DEPARTMENT OF TRANSPORTATION

49 CFR Part 571

Federal Motor Vehicle Safety Standards; Electric-Powered Vehicles; Electrolyte Spillage and Electrical Shock Protection

ACTION: Final rule.

Figure 1. S7.6.3 and S7.7 Measurement of Voltage Source Voltage

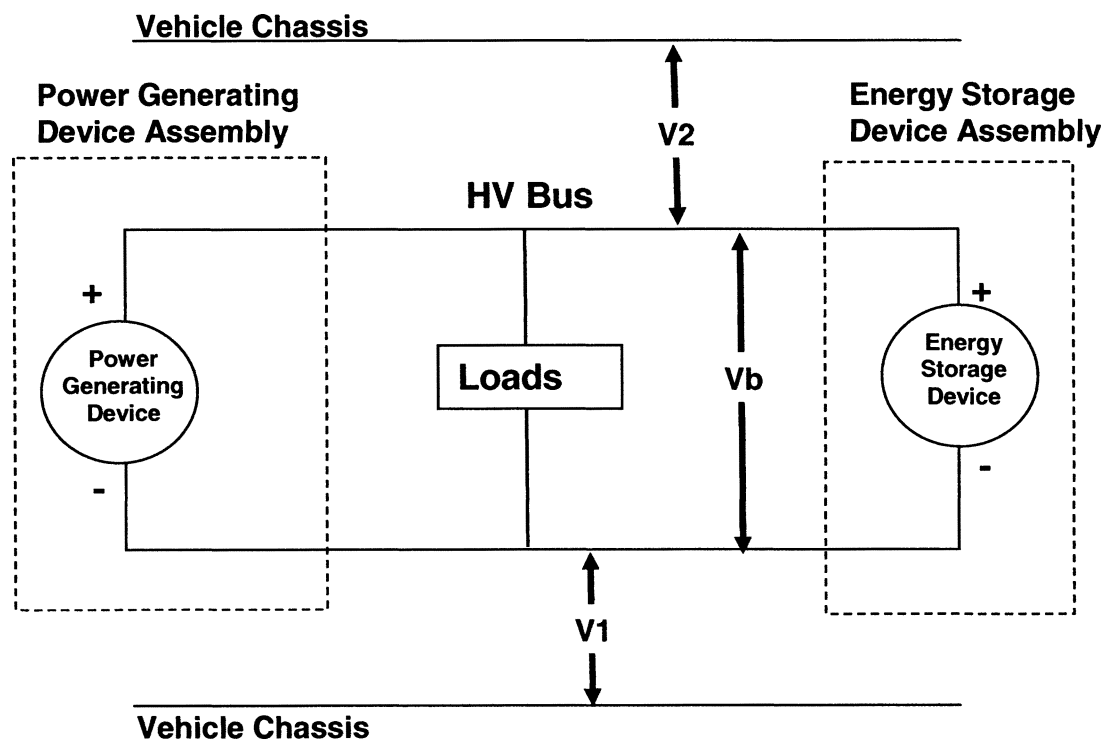
And fifth, the Alliance/AIAM suggested the following editorial corrections: Figure 1 should refer to S7.6.3, not S7.6.6; in Figure 4, V1 should be V1', and the denominator should be V1'; and in Figure 5, the denominator should be V2'.

We agree with these corrections and have revised the regulatory text accordingly.
